CITY OF KIRKLAND
Planning and Community Development Department
123 Fifth Avenue, Kirkland, WA 98033 425.587.3225
www.kirklandwa.gov

MEMORANDUM

To: Design Review Board
From: Jon Regala, Senior Planner
Date: September 8, 2014
File No.: DRV14-01332
Subject: EASTSIDE PREPARATORY SCHOOL EXPANSION – SCIENCE BUILDING & GYM DESIGN RESPONSE CONFERENCE

ALTERNATIVE 3 - FORMAL DEVELOPMENT

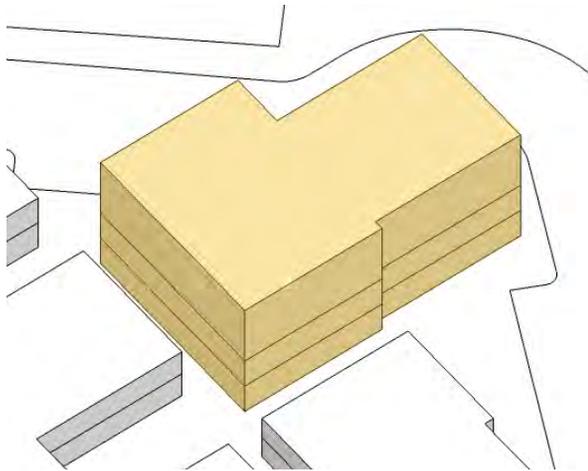
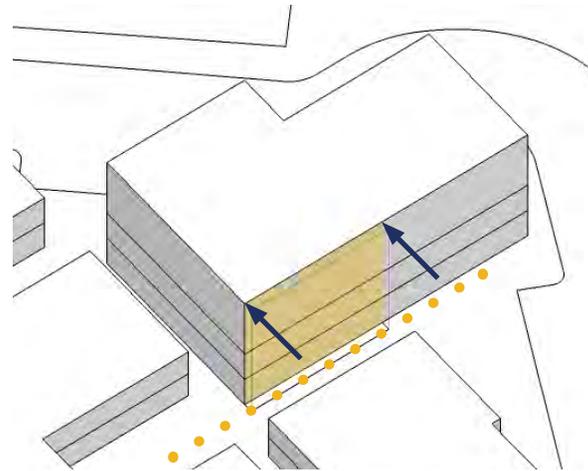
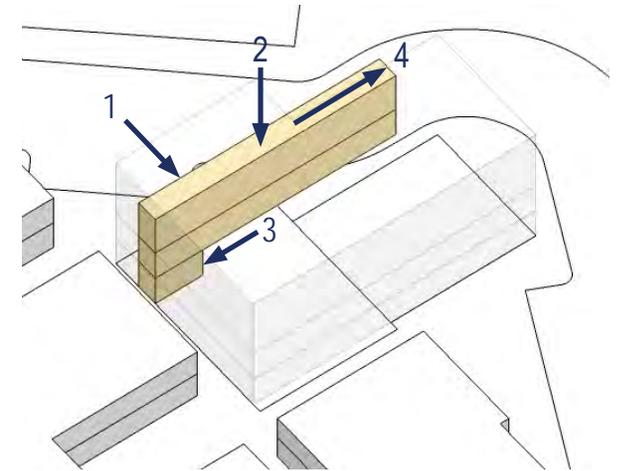
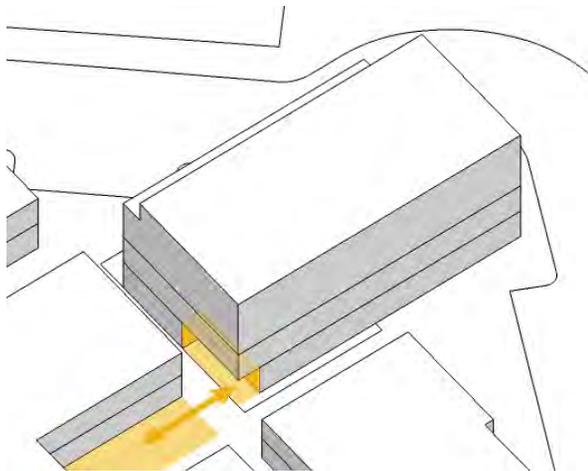
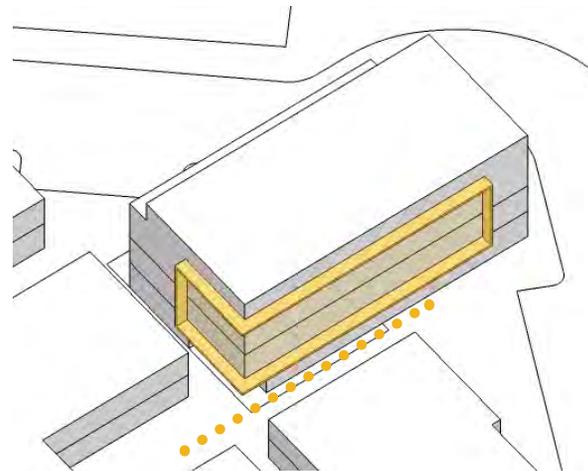
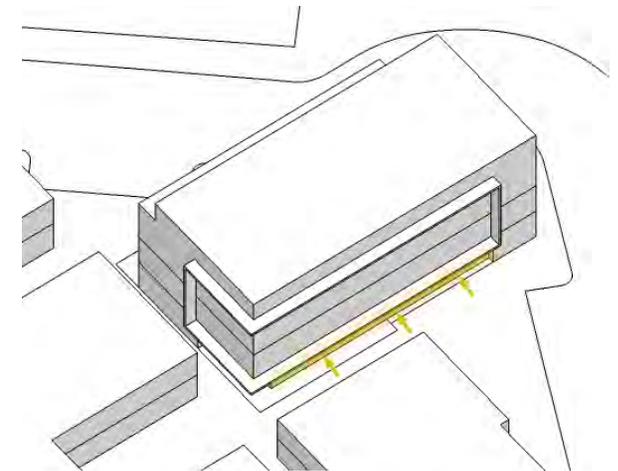
- a. DRB Discussion. The DRB expressed a preference for Massing Alternative #3 (see Attachment 5). Other recommendations and comments on the proposal by the DRB are summarized below.

- c. **Staff Analysis.** As requested by the DRB, the applicant has pursued Massing Alternative #3 and has provided detailed plans for review (see Attachment 6). **Also included in the applicant's design response were various** photo simulations, and perspective and section drawings as requested by the DRB.

The proposed building is 54' in height and measures approximately 131' by 74' at its outer perimeter. The building massing shown in the applicant's drawings are generally consistent with the Massing Alternative #3 presented at the Conceptual Design Conference except that building mass has been added to the top of the architectural bay element along the south façade (see diagram below – red box).

**HEIGHT CALCULATION
 [AVERAGE BUILDING ELEVATION DIAGRAM]**

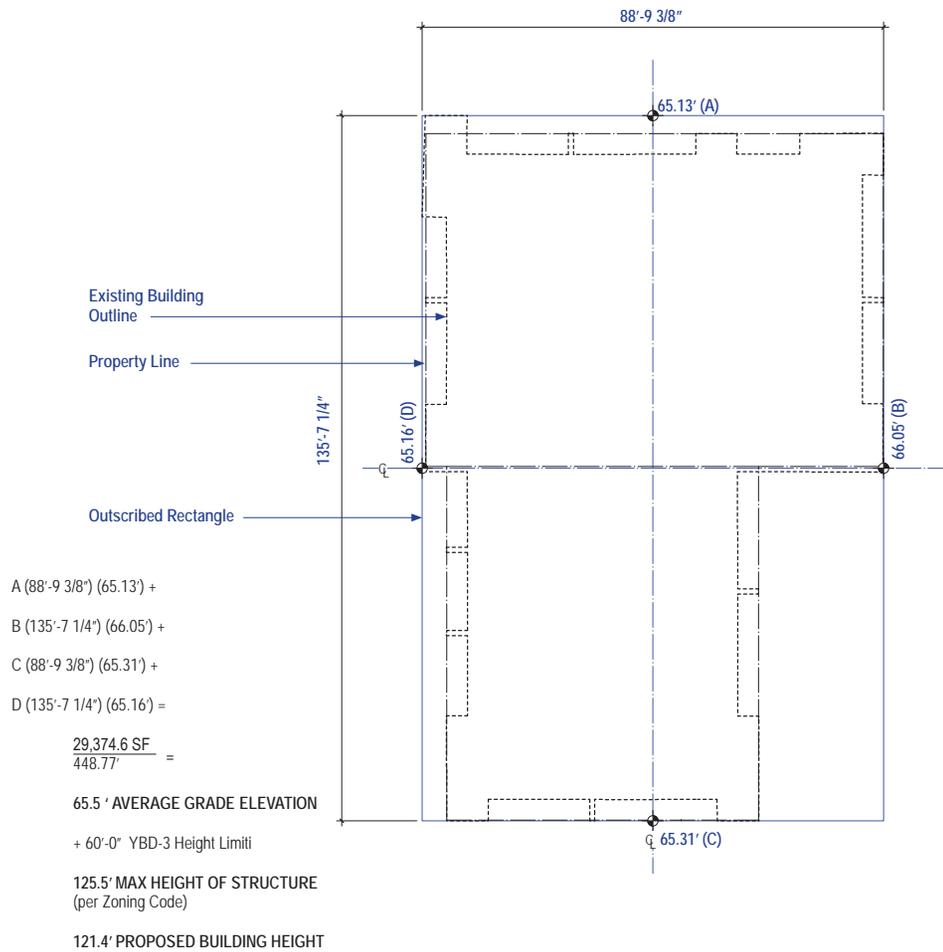
Staff Comment: Preliminary height calculations show that the proposed building is approximately 4' below the maximum height allowed. With the building permit application, the applicant should provide the height calculation site plan as a layer atop the survey information so that staff can confirm the topography and midpoint segments used. Staff's final review of the height calculation will occur with the building permit review.

LOT COVERAGE CALCULATION

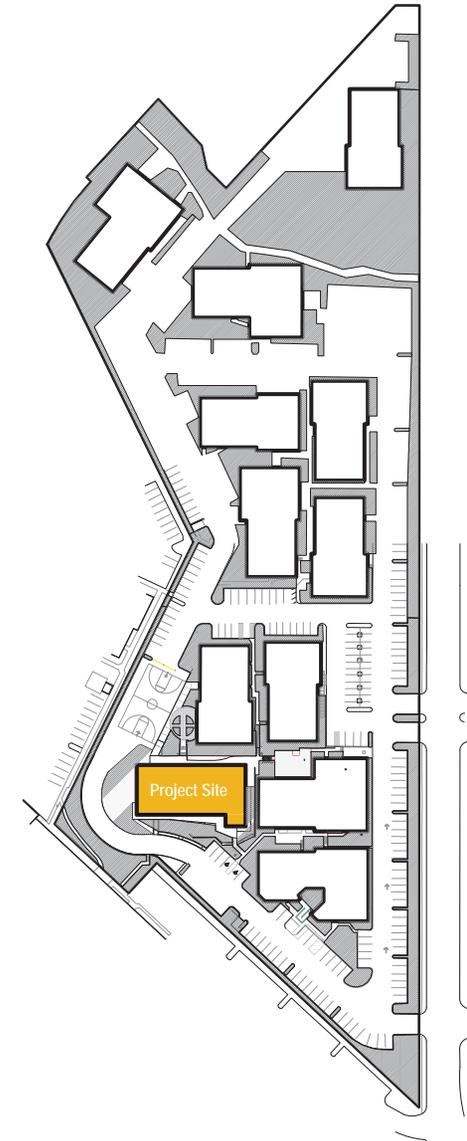
Staff Comment: Preliminary lot coverage calculations show that with the proposed changes, the entire Linbrook campus is at approximately 72% lot coverage. The applicant should submit final lot coverage information with the building permit application. Lot coverage information needs to include the entire Linbrook campus. Staff's final review of the lot coverage calculation will occur with the building permit review.

ALTERNATIVE 3 - FORMAL DEVELOPMENT
 DESIGN RESPONSE CONFERENCE - AUGUST 2014

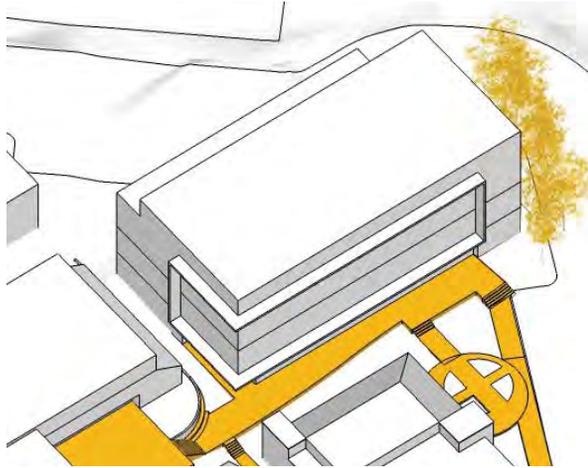
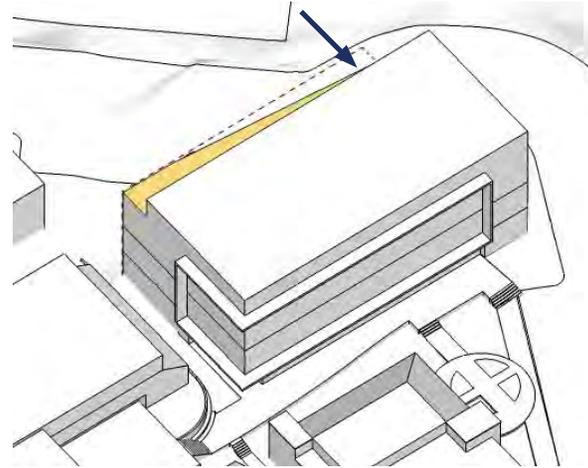
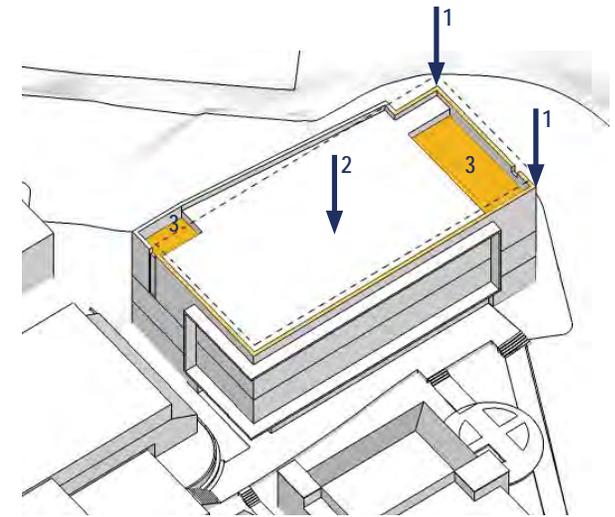
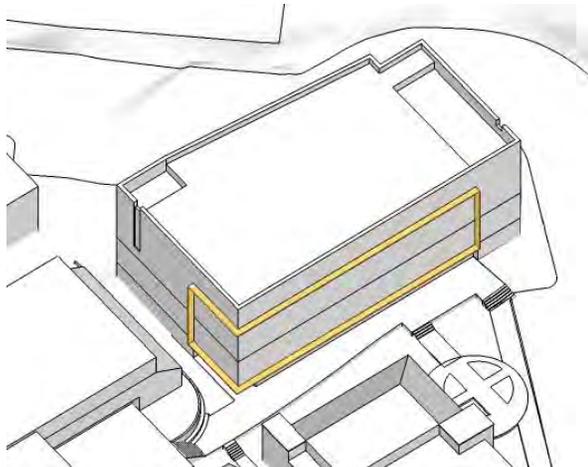
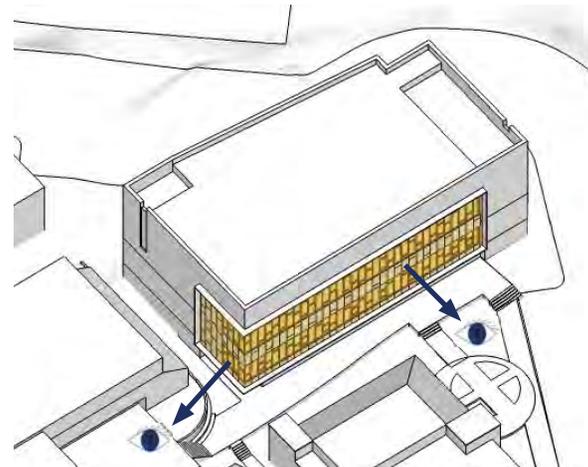
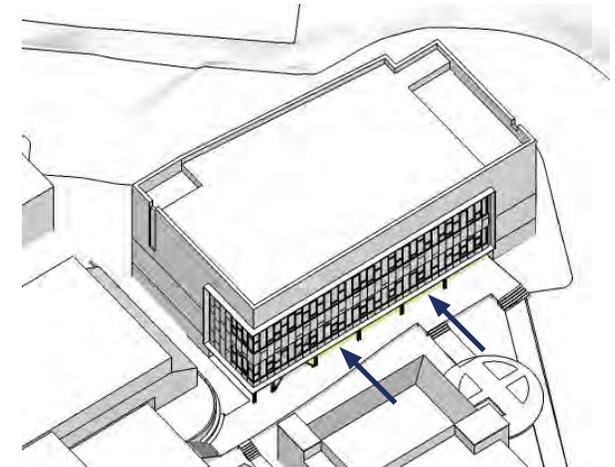
Staff finds that the west building elevation, which faces the play area (see also diagram above), and as it wraps around to the northwest and southwest, appears more imposing than the other facades. This is due to a lack of modulation, glazing, little change in materials/colors and lack of human scale features, resulting in portions of the facade appearing as a blank wall.

While the DRB was agreeable to the massing alternative for this façade, they were also interested in how the building scaling, articulation, and blank wall treatment would be addressed at this façade in particular given that the new building will be taller than the other buildings within the school campus. Also unique is that the building will house a school and gymnasium.

Given these concerns, there are a number of techniques which can be applied to this façade given its larger mass. One technique that can be used to help achieve horizontal definition and moderate the vertical scale of buildings is to **clearly identify a buildings' top, middle, and bottom**. To better define a **buildings' top**, articulation of the roof form using strong eave lines, cornice, and/or parapet treatments can be used. When viewing the roof plan for the project, two areas have been identified for mechanical equipment (see Attachment 6, page 18). Given this and the building being **4' below height** limit, there may be flexibility in varying the roof form. To establish a stronger base, pedestrian scale elements using materials such as concrete stone, masonry, stucco, etc. can perhaps be incorporated at the ground level.

- Determine if the building mass added at the top of the bay element along the south façade is acceptable.
- Review the west façade (facing the play area) and as it wraps to the northwest and southwest. Provide feedback in terms of addressing building scaling, articulation, and blank wall treatment.
- Are changes needed to the building when viewed from the key vantages: entrance at NE 38th Place and Northrup Way? If so, what additional details are needed from the applicant?
